# DSOX2024A-03

## S E R V I C E N O T E

DSOX2024A – Oscilloscope, Mixed Signal, 4 Channel,  
200MHz

**With the oscilloscope’s power on and while under normal operation the unit emits a hissing noise.**

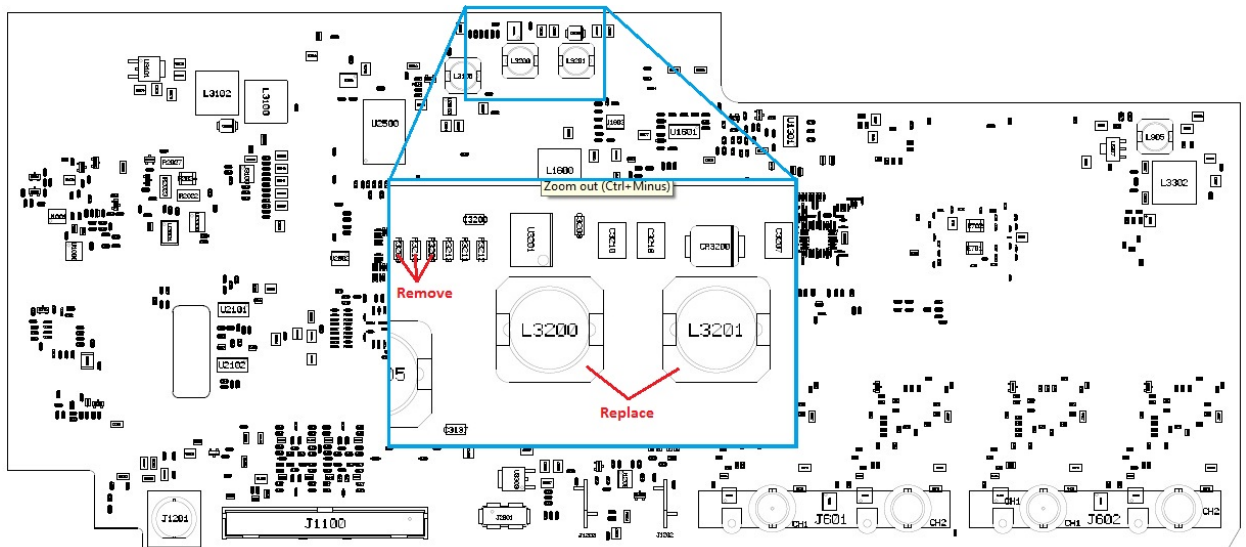
With the oscilloscope power turned on and while under normal operation, the unit emits a hissing noise.

2. As the picture indicates, remove the three resistors (0699-7209, 1 Ohm) located at R3208, R3209, and R3210. They are not to be replaced.
3. Remove as well the two inductors (9140-6474, 100uH) located at L3200 and L3201 and replace them with inductors with part number 9140-6151 (68 uH).
4. Re-assemble to the point where the unit could be powered up to verify that the hissing is indeed gone. If the hissing is not gone, please, check modifications.
5. When the hissing is gone, put oscilloscope back together.
